Federal Emergency Management Agency

This letter is in reference to a February 15, 2000, letter from Mr. Leonard Jackson, P.E., of Leonard Jackson Associates (LJA), to our Flood Map Production Coordination Contractor concerning a January 17, 2000, conditional Letter of Map Revision (LOMR) (Case Number 99-02-065R, copy enclosed) for proposed development along the Rio Grande De Loiza. In his letter, Mr. Jackson brought to our attention a scaling discrepancy in the description of the maximum decrease in floodway width in the aforementioned conditional LOMR, should the project be built as proposed, and asked that we clarify this issue. Additionally, this response will clarify the effective dates of the Flood Insurance Rate Map (FIRM) and the Flood Boundary and Floodway Map (FBFM) panels for the Commonwealth of Puerto Rico affected by this conditional LOMR.

Plaza Pinedo

ORIGINAL CROSS-SECTION / EXCAVATION PLAN -
FROM REPORT 8/27/99 - SUPERSEDED

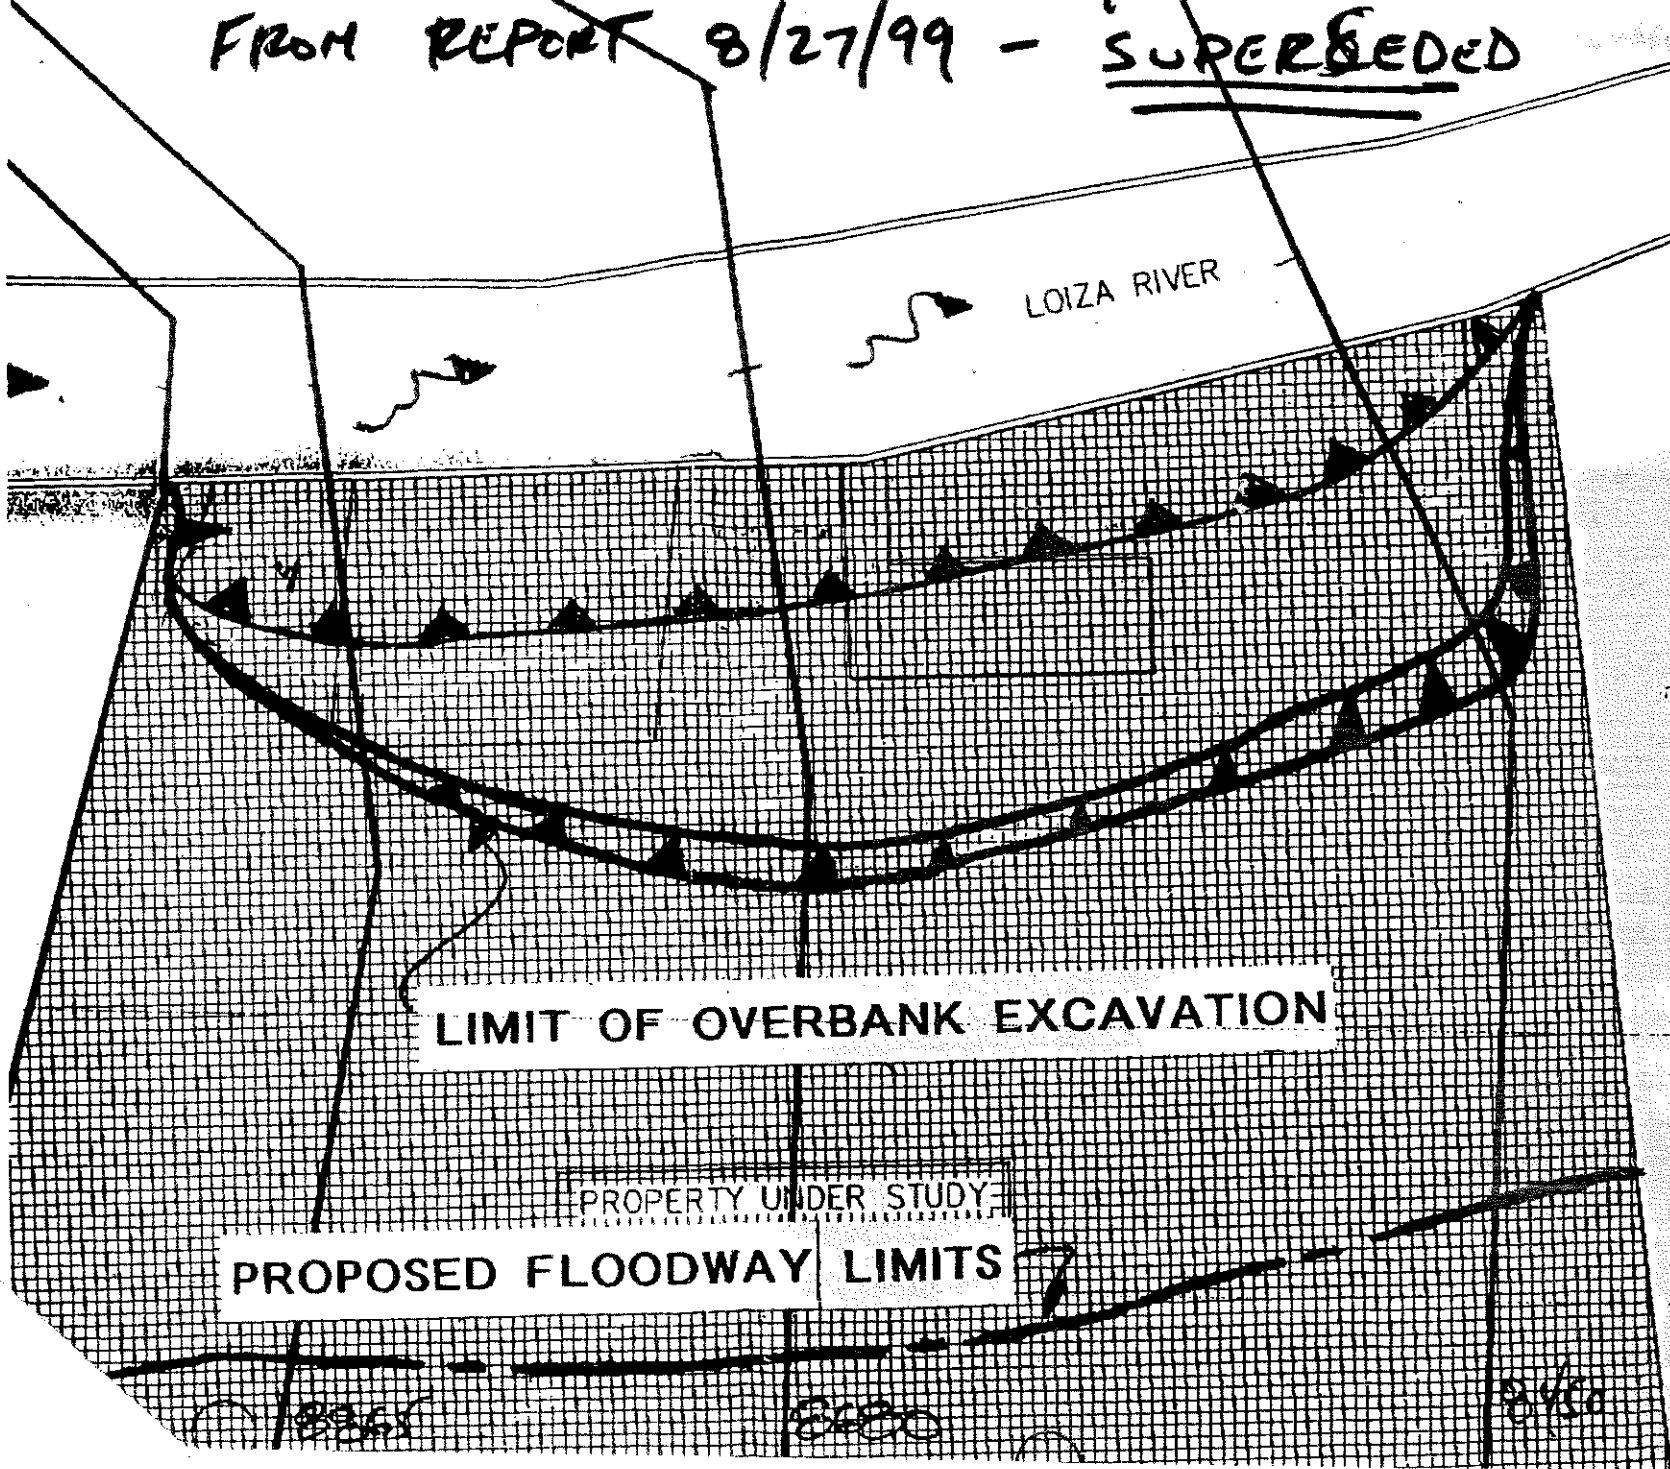
Henry - I've enclosed 3 plans which may clear up the confusion. The first is from the 8/27/99 report to DeWBerry & Davis. I think this is the one you were looking at while we talked on the phone. The second plan is from the 10/7/99 report to D&D. The excavation actually decreased for this report. This was done on purpose, in order to maintain velocities due to a constriction at section 6450. Making a bigger excavation results in lowering velocities, which results in higher water elevations at section 6450 only. DeWBerry did not like this increase, so we narrowed & tightened the excavation. The third plan shows the excavation as per the coding in our hydraulic model & is what I e-mailed you. We can discuss this further on Monday morning if you have questions. Thanks.
